SERVICE BULLETIN SB-40

SUBJECT: Emergency Pop-Out Float Pressure Cylinder Valve

ROTORCRAFT AFFECTED: R44 Helicopters with emergency pop-out floats thru S/N 0848 except S/N 0748, 0811, 0816, 0828, 0829, and 0831.

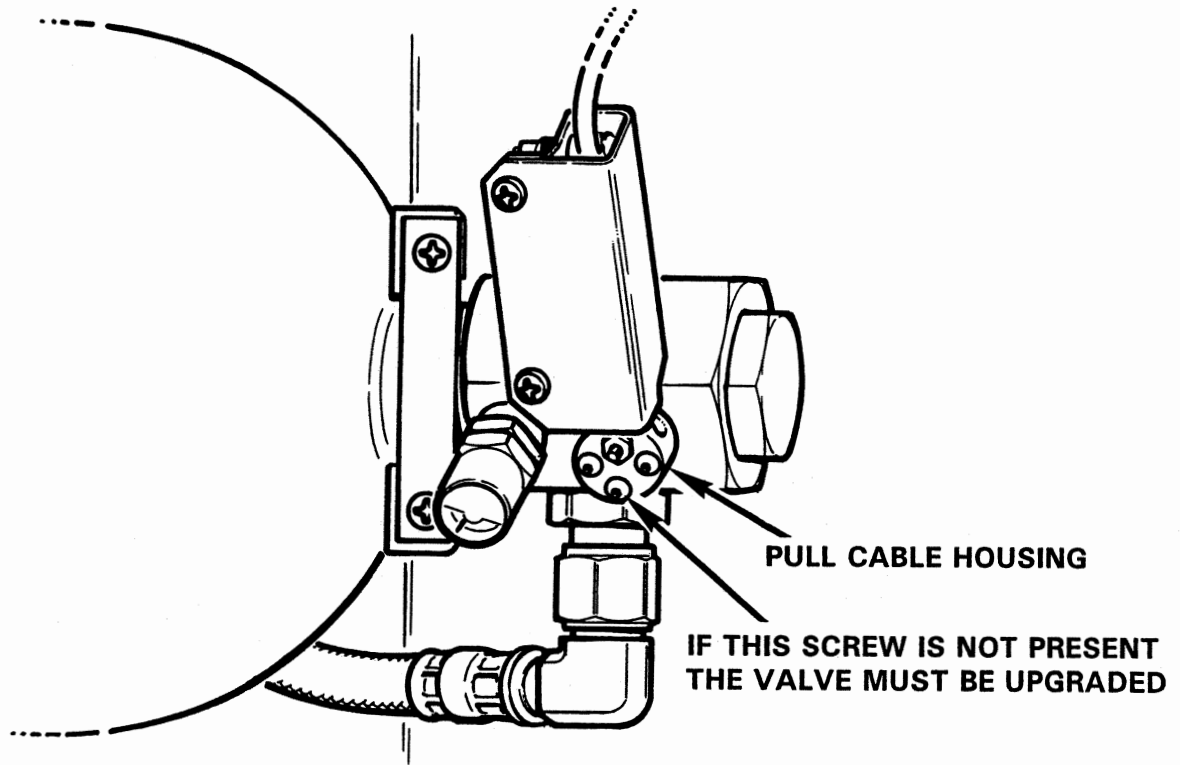
BACKGROUND: During a functional test of emergency pop-out floats, the floats failed to inflate due to a stuck pressure cylinder valve. This bulletin requires all pressure cylinder valves to be upgraded to ensure that the system will function properly.

NOTE: Upgraded valves can be identified by the number of screws retaining the pull cable housing. If there are two hold-down screws, the valve requires upgrading. Three screws indicate upgraded valve. See figure on page 2.

1. Order replacement D679-1 cylinder assembly and KI-151 cylinder pressure bleed-off kit from RHC Customer Service.
2. Depressurize cylinder using bleed fitting and instructions supplied in KI-151 kit.
3. Remove pressure cylinder per R44 MM section 5.660.
4. Install new D679-1 pressure cylinder per R44 MM section 5.670.
5. Ship empty cylinder and bleed fitting to RHC.
